# METROPOLITAN GOVERNMENT OF NASHVILLE AND DAVIDSON COUNTY

## STAFF RECOMMENDATION 2308 Belmont Boulevard December 21, 2016

**Application:** New construction-outbuilding/detached accessory dwelling unit; Setback determination

Figure 1: 2308 Belmont Blvd

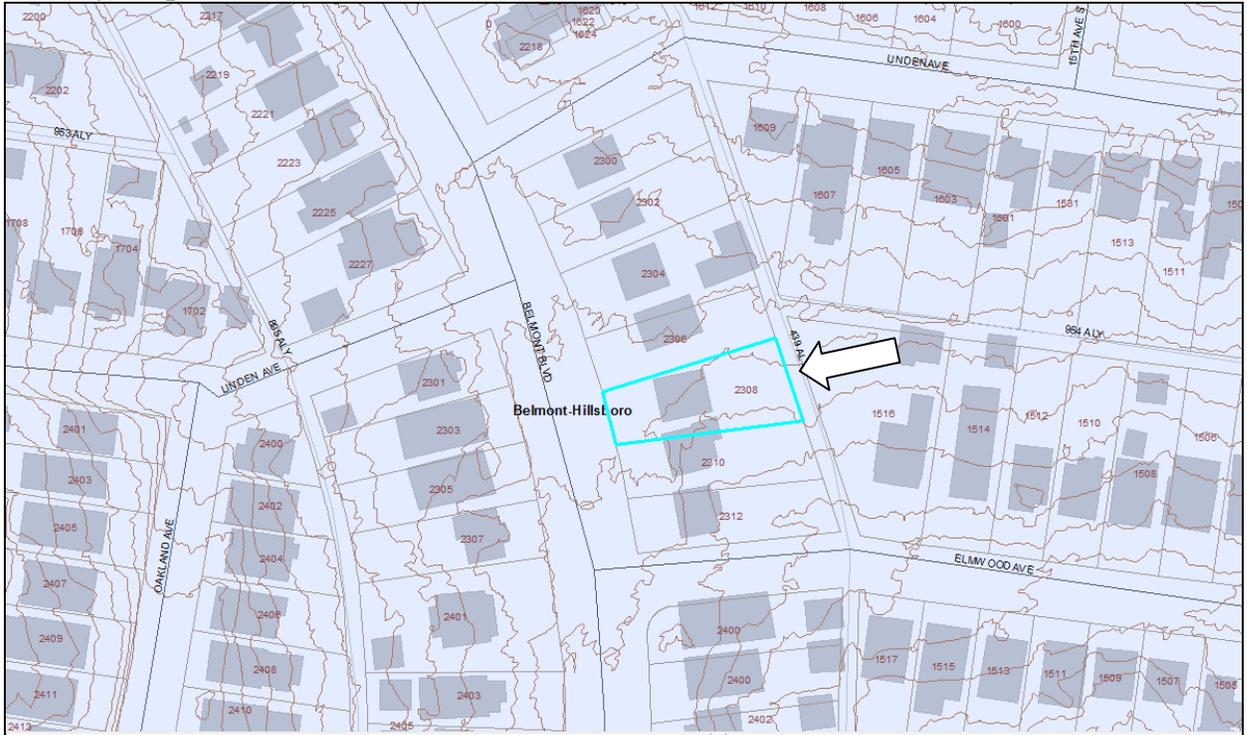
**Background:** The house located at 2308 Belmont Boulevard is a stone bungalow that was built c. 1915 (Figure 1). The house contributes to the historic character of the Belmont-Hillsboro Neighborhood Conservation Zoning Overlay.
